THREE MILE ISLAND NUCLEAR STATION, UNIT 1

AMENDMENT TO FACILITY OPERATING LICENSE

Amendment No. 5
License No. DPR-50

ATTACHMENT TO LICENSE AMENDMENT NO. 5
CHANGE NO. 5 TO THE TECHNICAL SPECIFICATION
FACILITY OPERATING LICENSE NO. DPR-50
DOCKET NO. 50-289

FIGURE 3.1-1

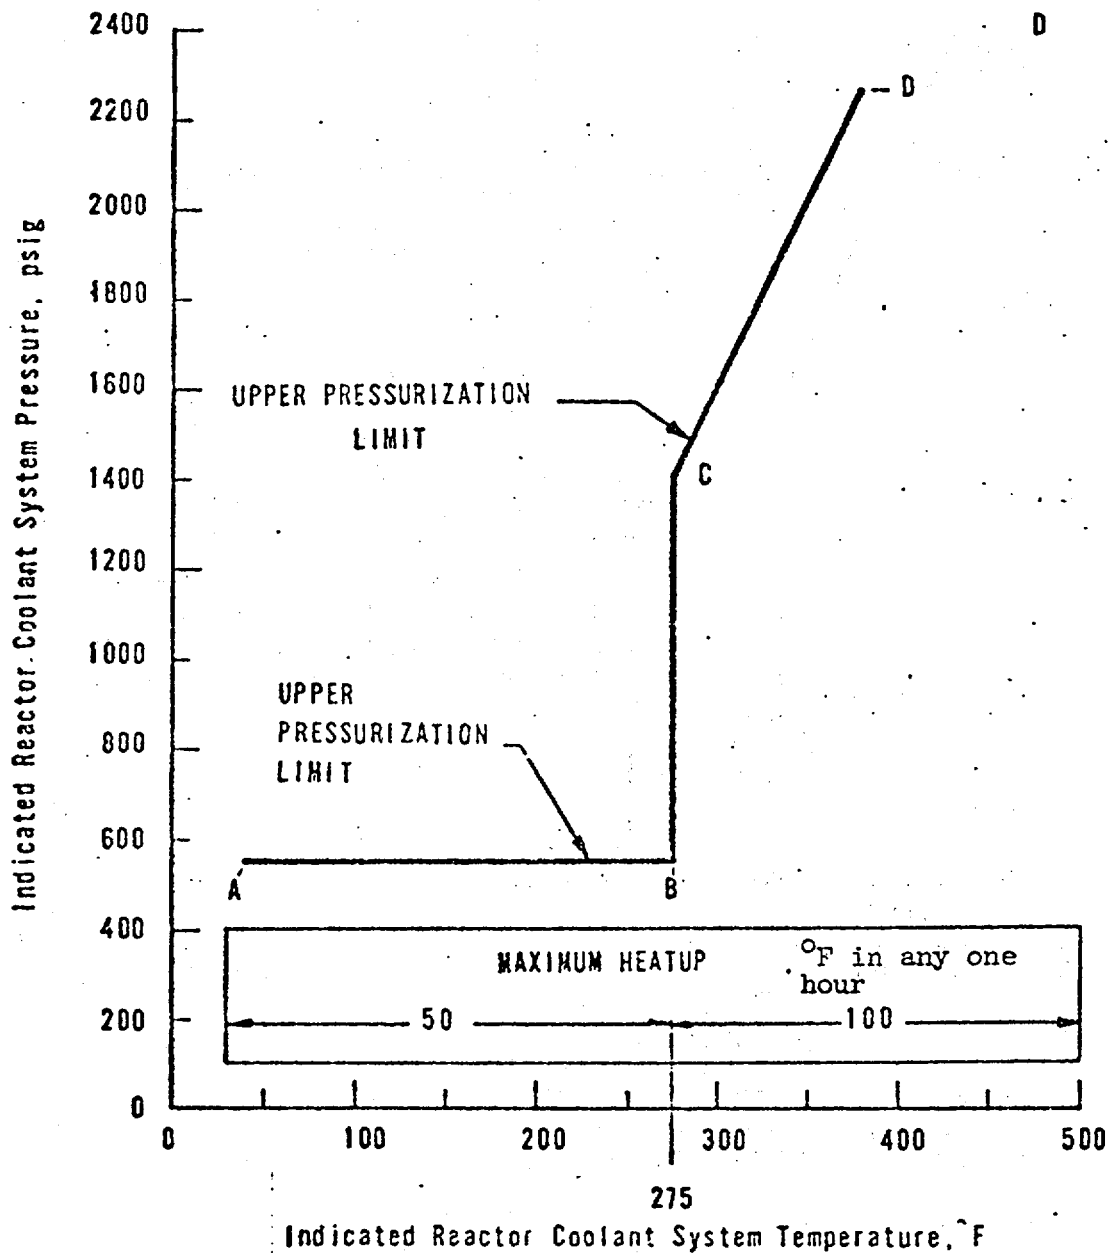
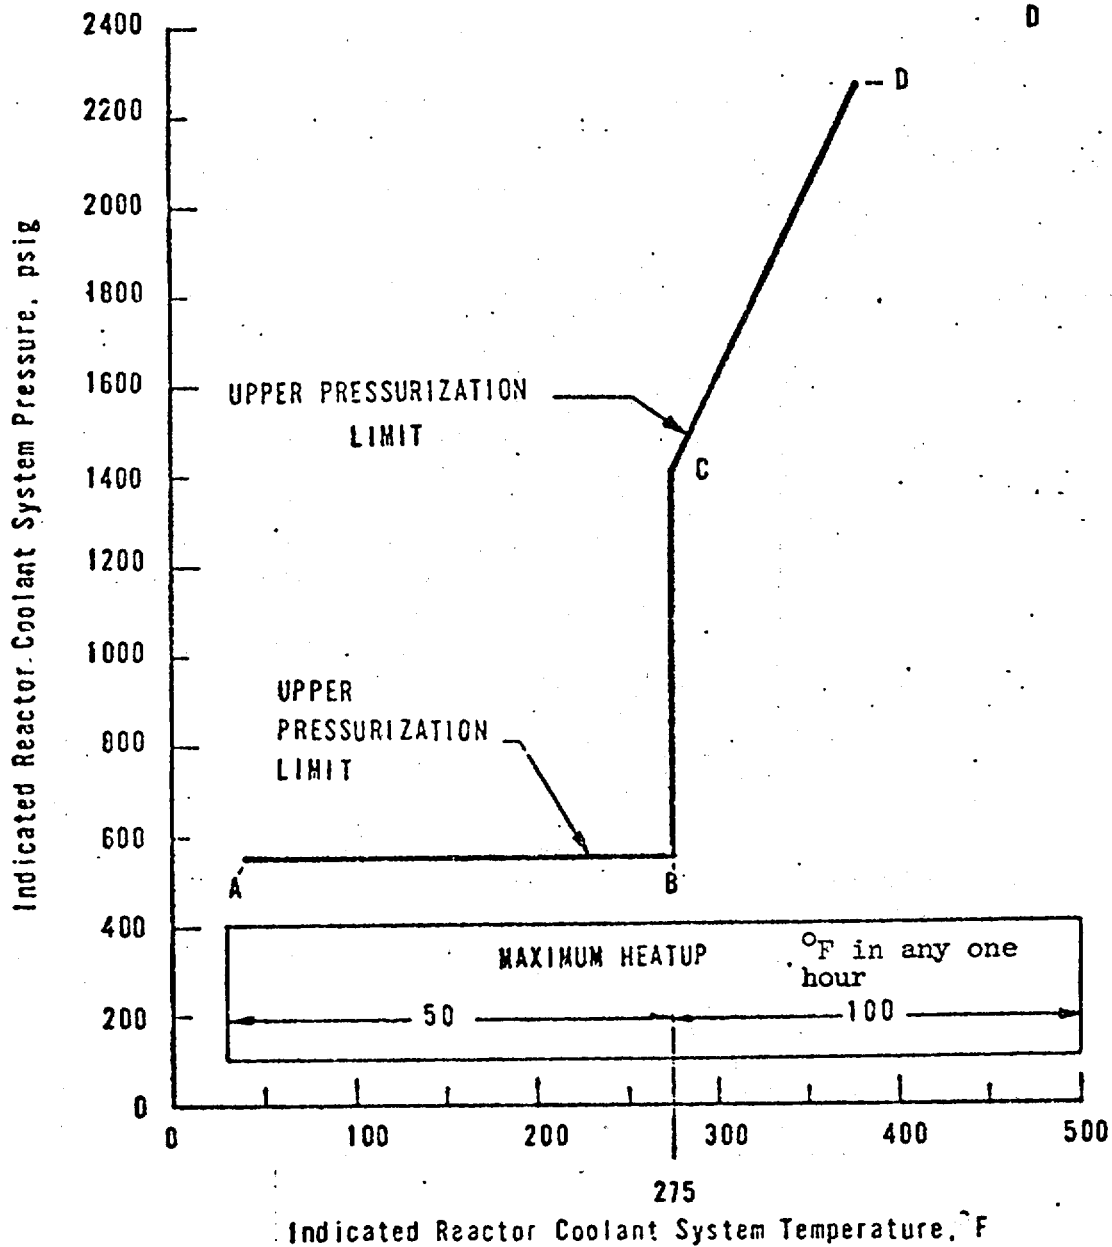
Replace pages 3-3, 3-4, and 3-5 with the attached revised pages.
Replace page 3-6 with the attached page (no change was made therein but
is being replaced for numbering sequence only). Also, replace Figures
3.1-1 and 3.1-2 with the attached revised figures.

Allowable combinations of pressure and temperature shall be to the right of and below the limit line in Figure 3.1-1. Heatup rates shall not exceed those shown on Figure 3.1-1.

For adequate conservatism, in lieu of portions of the Fracture Toughness Testing Requirements of the proposed Appendix G to 10 CFR 50, a maximum pressure of 550 psig and a maximum heatup rate of 50°F in any one hour has been imposed below 275 F as shown on Figure 3.1-1.

POINT	TEMP.	PRESS.
A	40	550
B	275	550
C	275	1400
D	380	2275

FIGURE 3.1-2

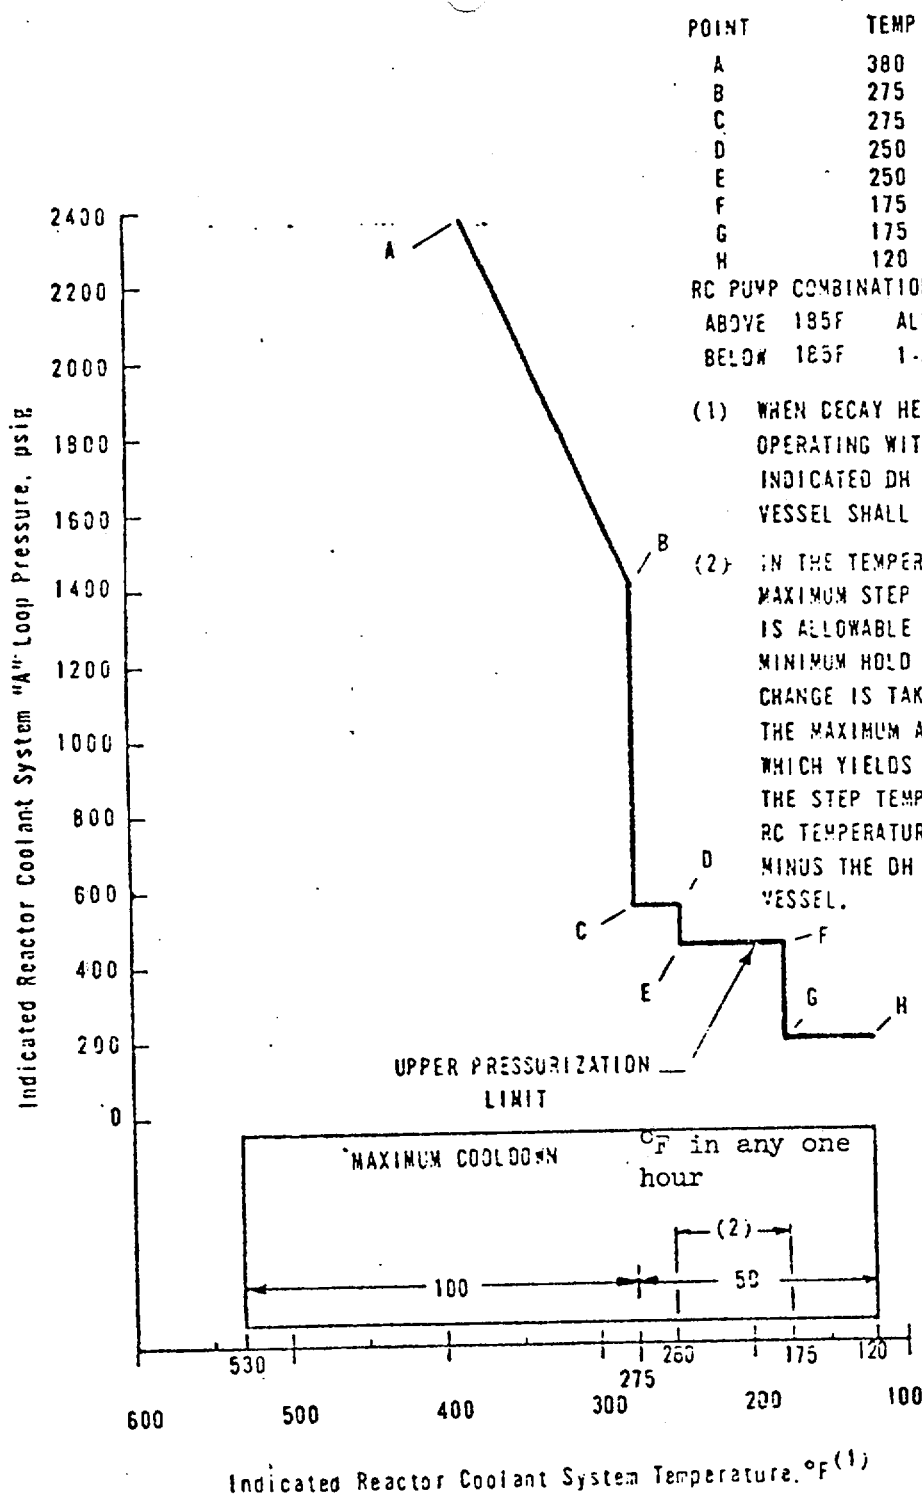
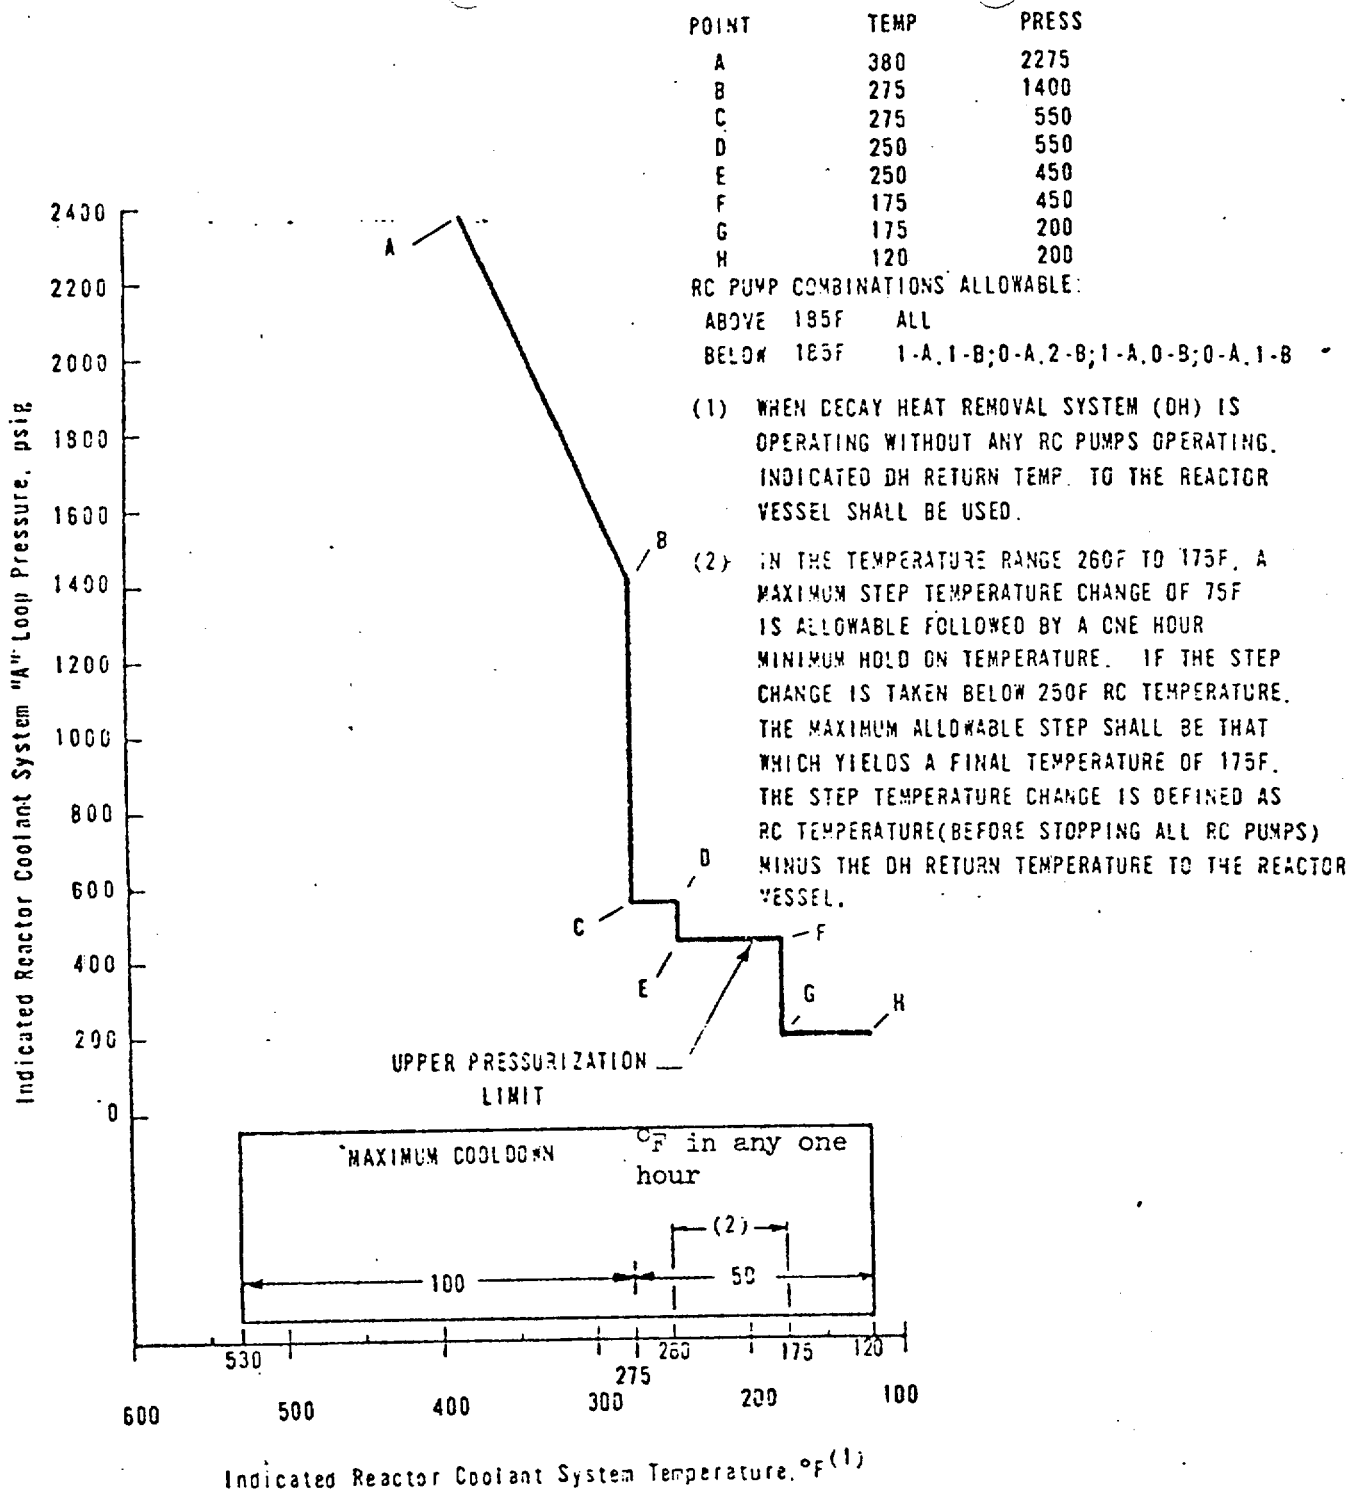
Allowable combinations of pressure and temperature for a specific cooldown shall be to the left of and below the limit line in Figure 3.1-2. Cooldown rates shall not exceed those shown on Figure 3.1-2.

- (1) WHEN DECAY HEAT REMOVAL SYSTEM (DH) IS OPERATING WITHOUT ANY RC PUMPS OPERATING, INDICATED DH RETURN TEMP. TO THE REACTOR VESSEL SHALL BE USED.
- (2) IN THE TEMPERATURE RANGE 260F TO 175F, A MAXIMUM STEP TEMPERATURE CHANGE OF 75F IS ALLOWABLE FOLLOWED BY A ONE HOUR MINIMUM HOLD ON TEMPERATURE. IF THE STEP CHANGE IS TAKEN BELOW 250F RC TEMPERATURE, THE MAXIMUM ALLOWABLE STEP SHALL BE THAT WHICH YIELDS A FINAL TEMPERATURE OF 175F. THE STEP TEMPERATURE CHANGE IS DEFINED AS RC TEMPERATURE (BEFORE STOPPING ALL RC PUMPS) MINUS THE DH RETURN TEMPERATURE TO THE REACTOR VESSEL.

POINT	TEMP	PRESS
A	380	2275
B	275	1400
C	275	550
D	250	550
E	250	450
F	175	450
G	175	200
H	120	200
